SUBDIVISION REVIEW SHEET**CASE NO.:** C8-2020-0174.0A**Z.A.P. DATE:** February 2, 2021**SUBDIVISION NAME:** Rome Hudson Subdivision**AREA:** 1.64 acres**LOTS:** 2**APPLICANT:** Rome LLC**AGENT:** WGI
(Thomas Lombardi, Jr.)**ADDRESS OF SUBDIVISION:** 6002 Hudson Street**WATERSHED:** Fort Ranch**COUNTY:** Travis**EXISTING ZONING:** CS-MU-CO-NP**JURISDICTION:** Full Purpose**PROPOSED LAND USE:** Office**VARIANCE:** none**STAFF RECOMMENDATION:**

CITY OF AUSTIN –DEVELOPMENT SERVICES DEPARTMENT
SUBDIVISION APPLICATION – MASTER COMMENT REPORT

CASE NUMBER: C8-2020-0174.0A
 REVISION #: 00
 CASE MANAGER: Cesar Zavala

PROJECT NAME: Rome Hudson Subdivision
 LOCATION: 6002 HUDSON ST

ROME HUDSON SUBDIVISION City of Austin, Travis County, Texas

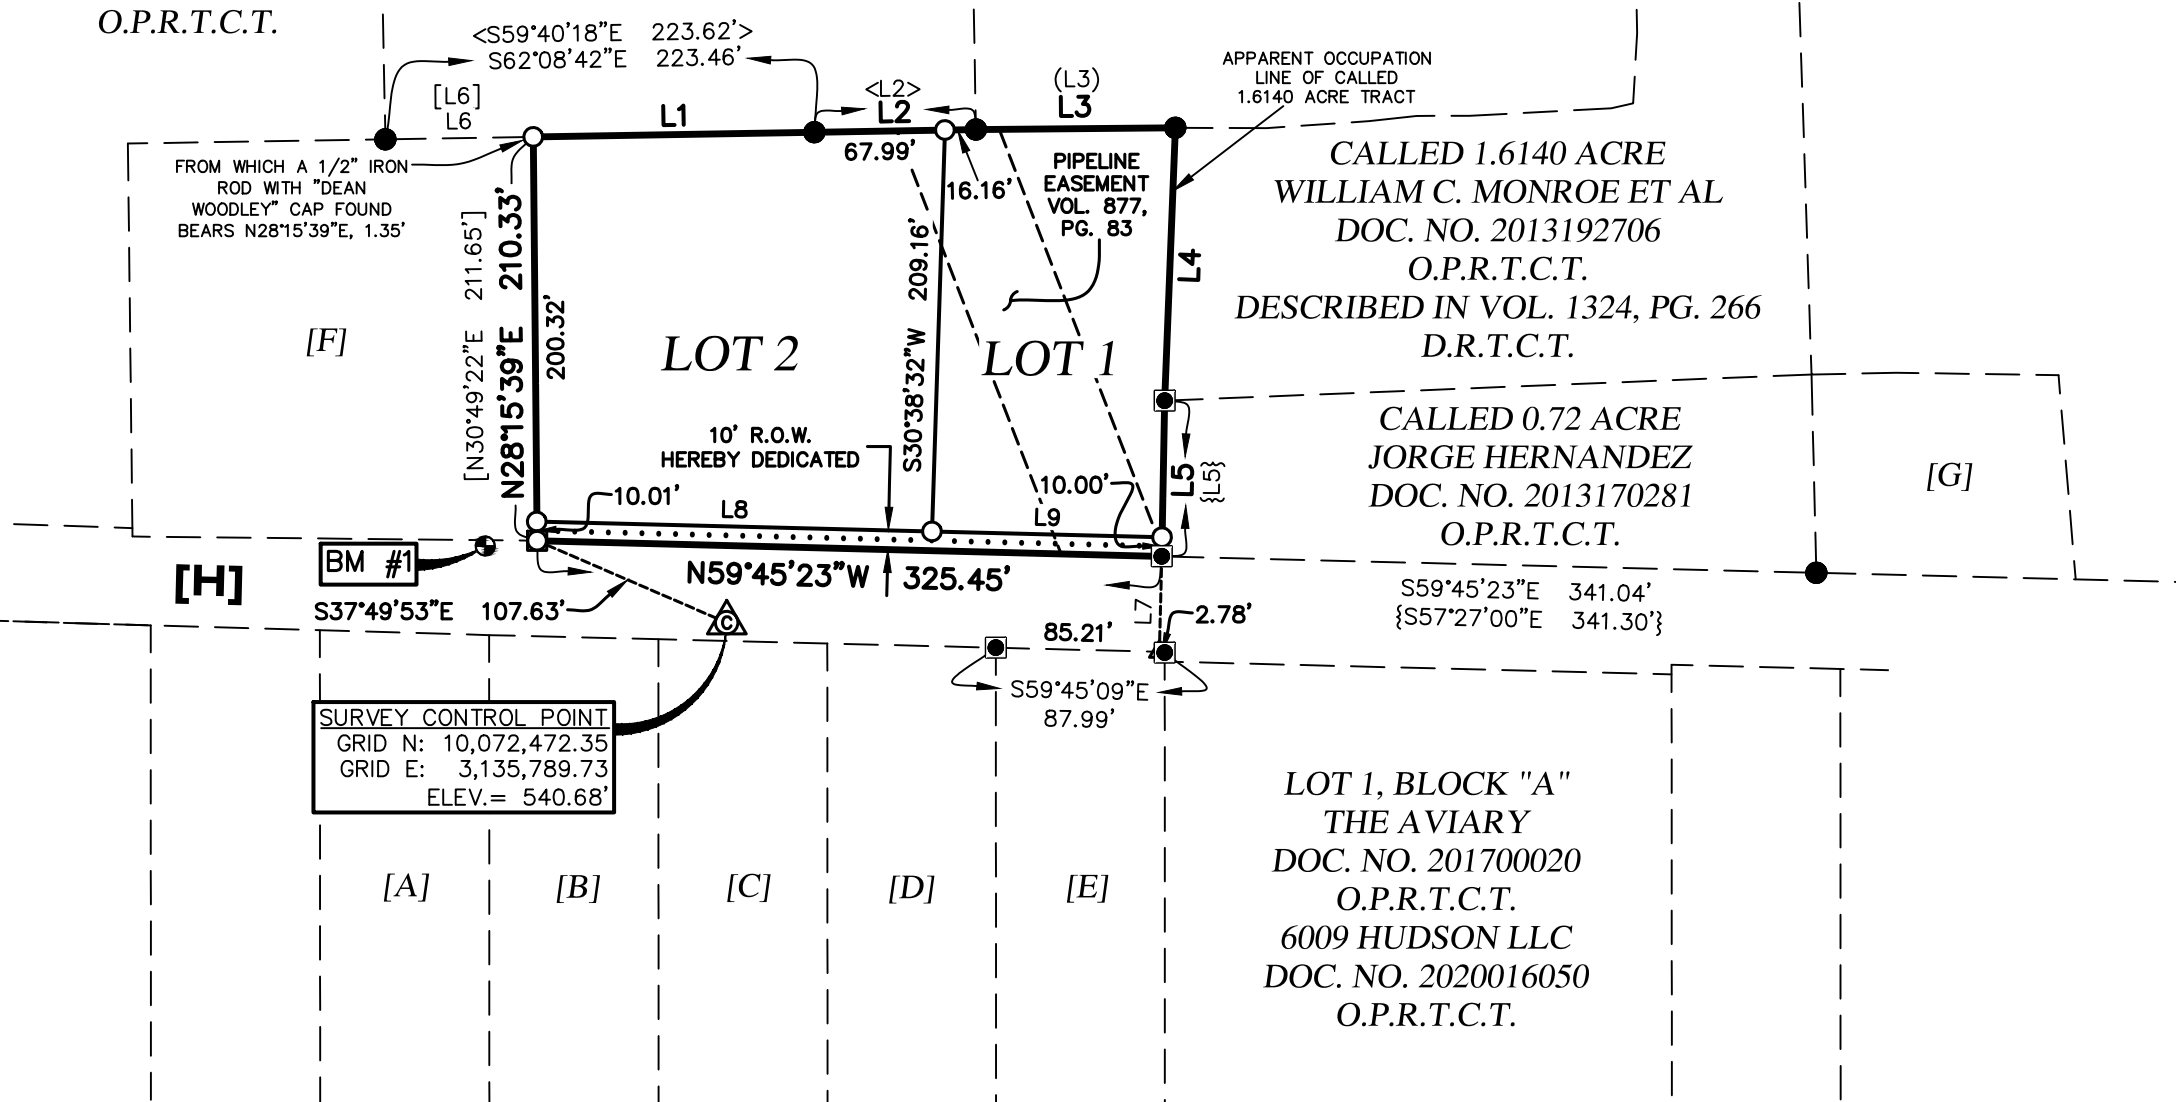
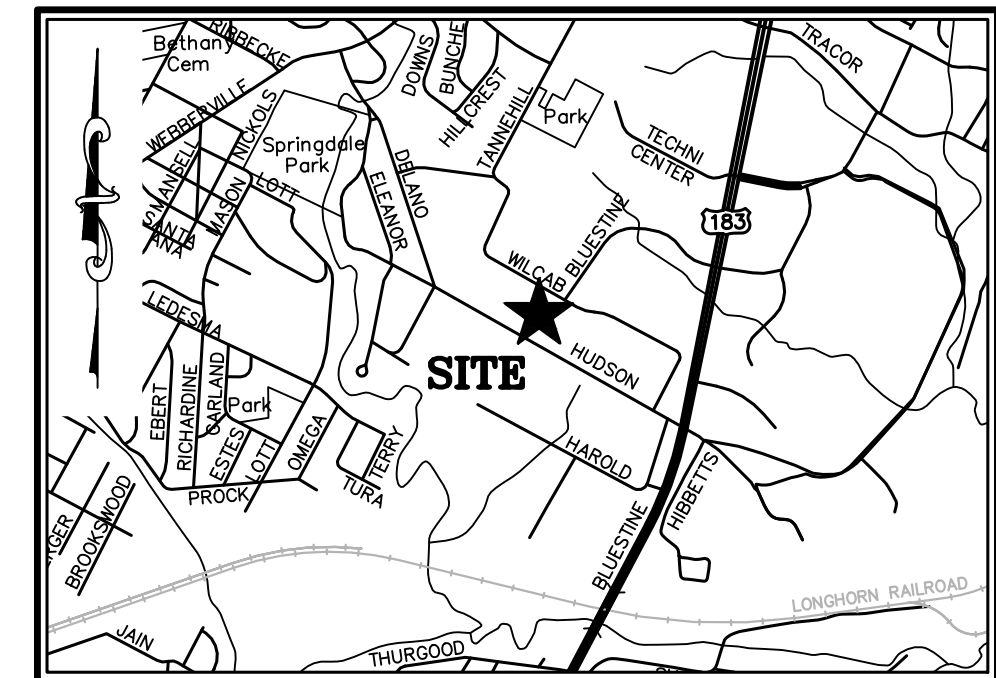
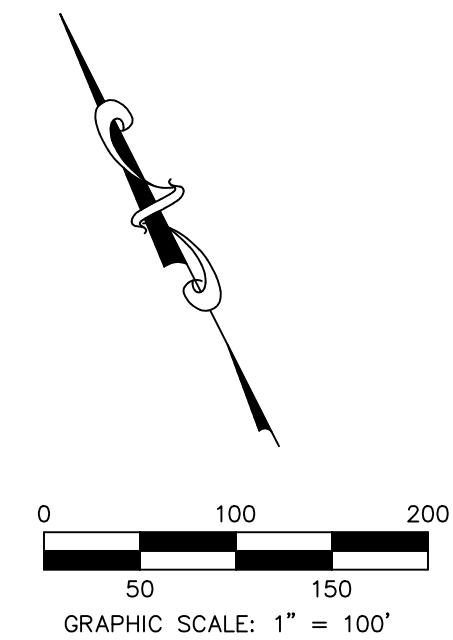
Ten (10') foot electric distribution, electric telecommunications, and electric fiber easement is required adjacent to Hudson St. Show the easement on the face of the plat.

AD1: This plat review is rejected for the following reasons: HUDSON ST is incorrectly labeled

AD2: The label for HUDSON ST must be shown on the ROW

AD3: Please remove the present label [H] and replace with HUDSON ST
§25-4-155

TR1. The Austin Strategic Mobility Plan (ASMP) requires 60 ft. of right-of-way (ROW) along this section of Hudson Street. 30 ft. of ROW is required from the centerline of Hudson Street. It appears that 40 ft. of ROW is made available from centerline through 10 ft. dedication. Please explain if centerline is unusual. A 5' dedication may only be required. Comment may be cleared informally.

- SR 1. Show all existing easements on the plat, annotate easements accordingly if provided by separate instruments. (L.D.C 25-1-83)
- SR 2. The plat is demonstrating a pipeline easement, verify if the plat should comply with the Hazardous Pipeline section of the Land Development Code, Sections 25-4-134 and 25-2-516. If the pipeline meets the definition of a Hazardous Pipeline, the lots will need to comply with lot sizes as stated in 25-4-134(D) and other requirements as listed by code. A sign off or acknowledgement that the pipeline is not considered a Hazardous Pipeline will be needed from the Fire Department reviewer to clear this comment.

- SR 3. Show the application submittal date on the plat, January 4, 2021. (L.D.C 25-1-83)
- SR 4. Include the case number on the lower right corner of each plat sheet, C8-2020-0174.0A. (LDC 25-1-83)

- SR 5. Verify the scale on the plat measures correctly to avoid future amendments on the plat during the construction or site plan phases. (L.D.C 25-1-83)

- SR 6. Remove the scale measurement from below the location map. (L.D.C 25-1-83)
- SR 7. The site contains existing structures.
- If the structures will be removed or demolished, the plat can be approved, but will not be recorded until the structures are demolished. The plat must be recorded no later than 80 business days after approval. 25-1-83

- SR 10. Delete plat Note # 9 referencing uses on the lots. The lots will follow development requirements set by zoning or ordinances.

SR 12. Will fiscal be required for the case? If fiscal is needed for the case replace Note #11 with the following note. A construction agreement will be generated by the Fiscal Office if a fiscal amount is posted.(25-1-83)
